1 Products affected

| Product Change Notification | | | | | FAS inscription | | |
| owner | creation date | release date | released by | change order no | rev | page | D10-040-167 |

| Old product appearance | New product appearance |

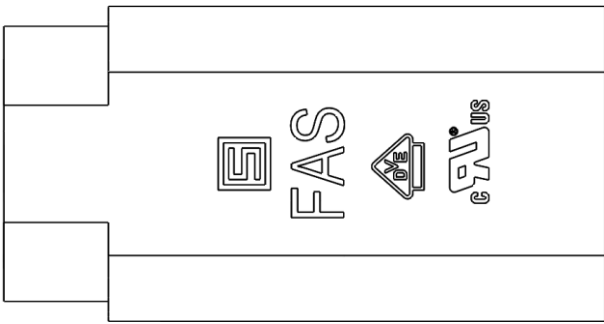
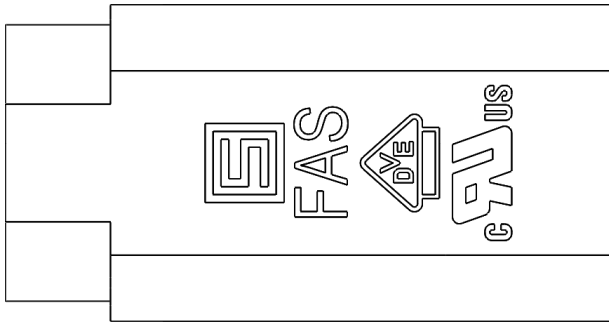
Enlarge the markings on the fuse holder.

- Better readability of the markings

The change will be rolled-out starting ww 10/2020 (Date code 2010 or higher on label).
